Monticello Nuclear Generating Plant
Docket No. 50-263
Renewed Facility Operating License
No. DPR-22

Response to a Request for Additional Information for the Monticello Nuclear Generating Plant Related to the Amendment to Adopt Advanced Framatome Methodologies (EPID: L-2021-LLA-0144)

**MONTICELLO ADVANCED METHODS LAR – RESPONSE TO REQUEST
FOR ADDITIONAL INFORMATION**

ANP-4005NP
Revision 0

Figure 3-2 Monticello Power / Flow Operating Domain

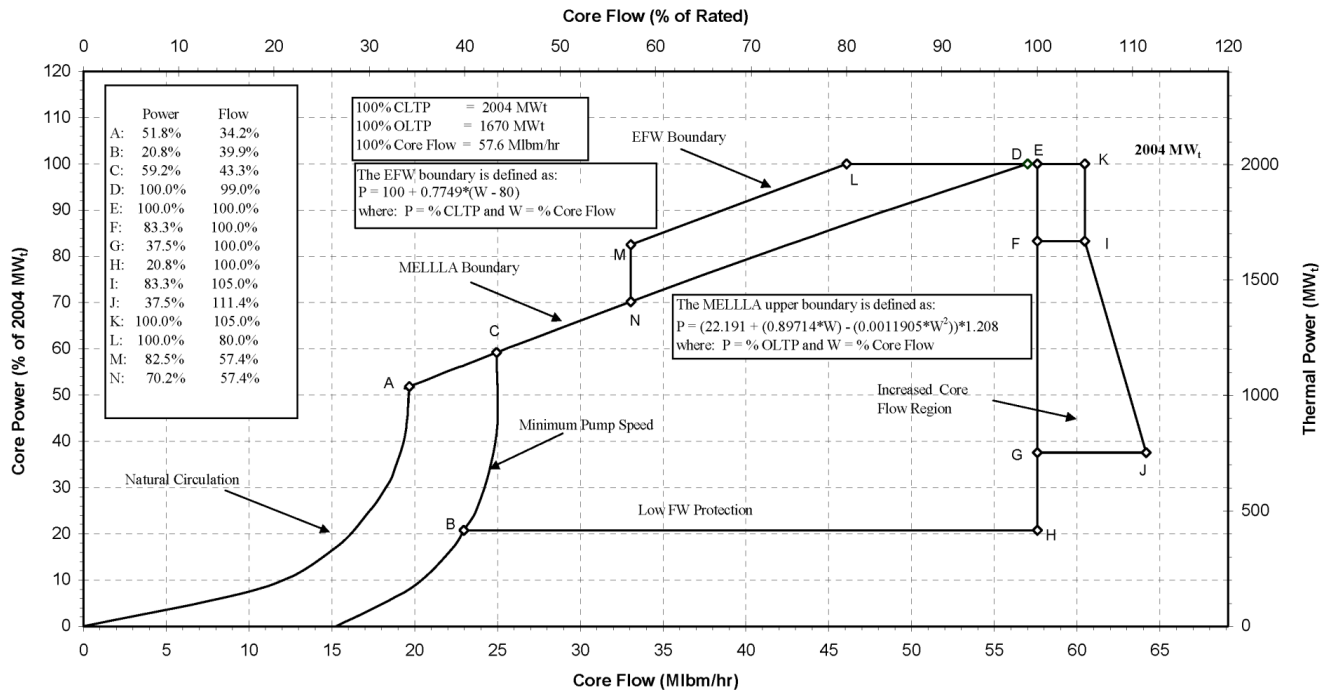
Section 3.2 of ANP-3893P states that the ATRIUM 11 fuel assemblies are hydraulically compatible with the co-resident ATRIUM 10XM fuel design for the entire range of licensed power-to-flow operating map. Clarify this statement and elaborate whether the hydraulic compatibility between ATRIUM 10XM and ATRIUM 11 fuel designs for all combinations of power-to-flow operating map and extended flow window during transition cycles as well as for full-core ATRIUM 11 at MNGP.

The Monticello Thermal-Hydraulic Design Report for ATRIUM 11 Fuel Assemblies (ANP-3893P) presents results for two power-to-flow state points (100%P/100%F and 59.2%P/43.3%F) and various core loadings as the plant transitions from a full core of ATRIUM 10XM fuel to a full core of ATRIUM 11 fuel. These results are a subset of all the analyses performed to support the conclusion that the ATRIUM 11 and ATRIUM 10XM fuel are thermal-hydraulically compatible. Similar thermal-hydraulic compatibility analyses were also performed at the following power-to-flow state points: 100%P/105%F, 100%P/80%F, 82.5%P/54.7%F, 25%P/100%F and 25%P/41%F. The results from all the analyses, including the additional power-to-flow state points, show that the thermal-hydraulic design criteria are met. Comparing all the state points analyzed with the power-to-flow operating map shown in Figure 3-2, shows that analyses were performed across the entire power-to-flow operating domain, including the extended flow window.
